REMARKS

Claims 2-18 remain in this application. Claims 1 and 19 have been canceled. Claims 2, 4, 5, 8, 13, and 17 have been amended.

RED INK
CHANGES
02/14/2006

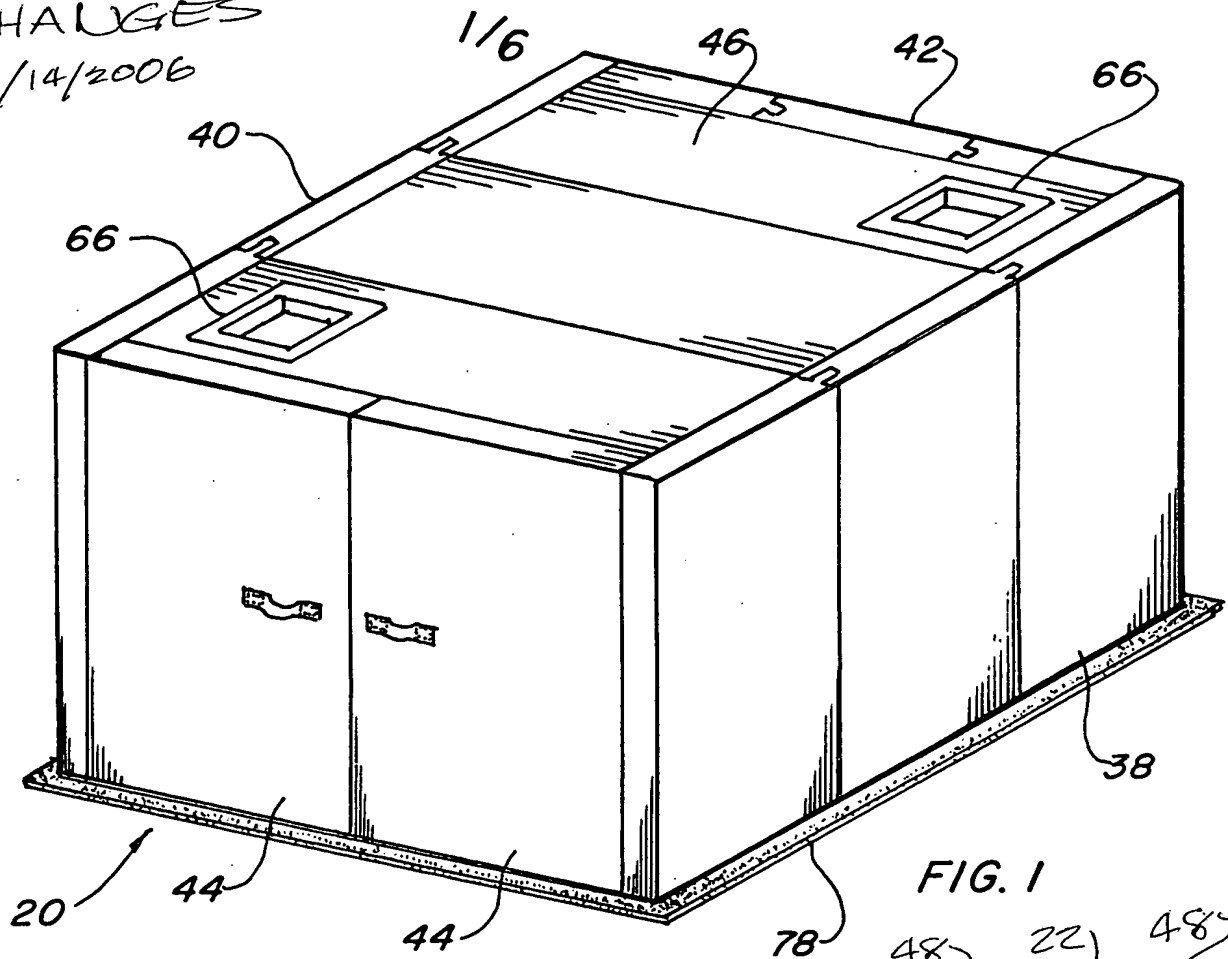
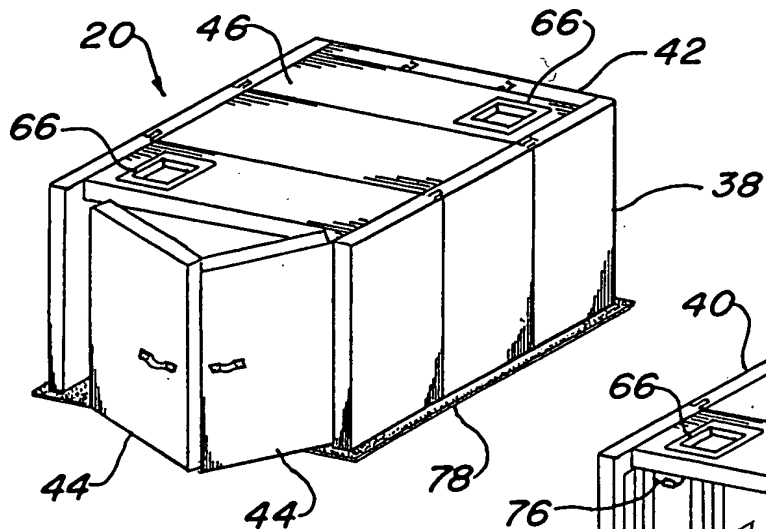
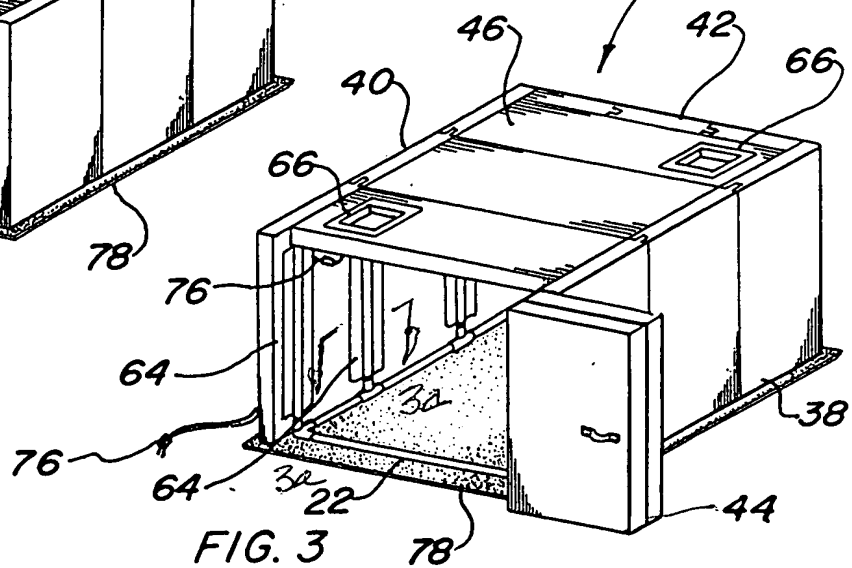
The drawings were objected to under 37 CFR 1.83(a) as they must show every feature of the invention described in the specification and specified in the claims. The examiner indicated that the hook and loop fastener attached by overlapping the fasteners from adjacent panels around the frame must be shown or the feature canceled from the claims. Applicant is furnishing a replacement sheet illustrating the overlapping hook and loop fastener over the frame in the cross section of the added FIGURE 3a. Since the hook and loop fastener known by its trade name VELCRO is well known in the art and the fact that which side of the hook or loop is physically located is irrelevant as they are completely interchangeable. No new matter has been added as the drawings illustrated their presence as element 64 and the specification clearly disclosed their location on each side of the frame.
